6th Floor Office Renovation/Arlington High School

# ADDENDUM NO. 1

6<sup>TH</sup> FLOOR OFFICE RENOVATION ARLINGTON HIGH SCHOOL

SKE-1

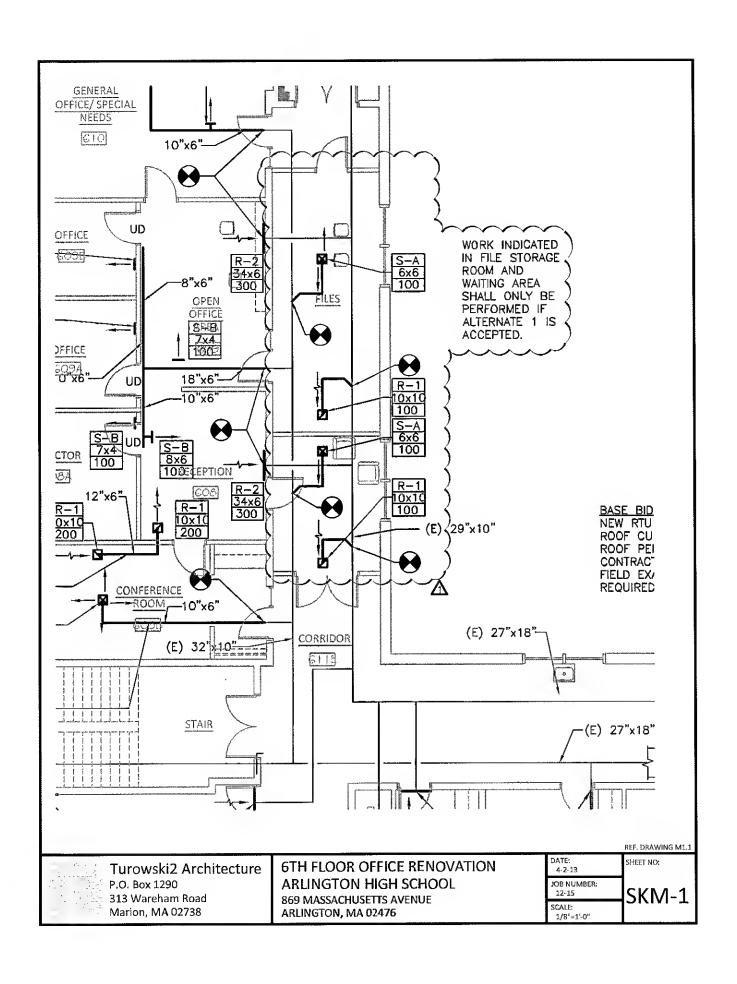
B. Incorporate the clarifications and/or revisions on the following sketch: SKE-1.
- AD1-6 DRAWING E2.1 NEW POWER PLAN ELECTRICAL
  - C. Incorporate the clarifications and/or revisions on the following sketch: SKE-2.

POWER SUPPLY FOR MAGNĚTIC LOČKS ANĎ EL ĚCTRIC LOCKS FURNISHED @ DOOR BY DOOR HARDWARE CONTRACTOR. ELECTRICAL CONTRACTOR SHALL SUPPLY 120 VAC CIRCUITS. TIE IN PER E.C. EXACT REQUIREMENTS, WIRED & INSTALLED BY E.C. CONTRACTOR. PT

ELECTRIC LATCH RETRACTION DEVICE FURNISHED AND INSTALLED BY HARDWARE CONTRACTOR, WIRED BY ELECTRICAL CONTRACTOR. E.C. TO PROVIDE 3/4" CONDUIT TO NEAREST ACCESSIBLE CERMING SPACE. EC

ELECTROMAGNETIC LOCK - F&I BY HARDWARE, WIRED BY E.C.  $\mathbb{M}$  ELECTRIC LOCK FURNISHED AND INSTALLED BY HARDWARE CONTRACTOR, WIRED BY E.C. 3/4" CONDUIT AND PULL STRING BY E.C.

4" SQ. x 2 1/2" DOOR JUNCTION BOX BY EC.

ĚLEČTRIC HÌNGE DEVICE FURNISHEĎ ANĎ INŠTALLED BY HAŘDWARE CONTŘAČŤOR, H

WIRED BY E.C.
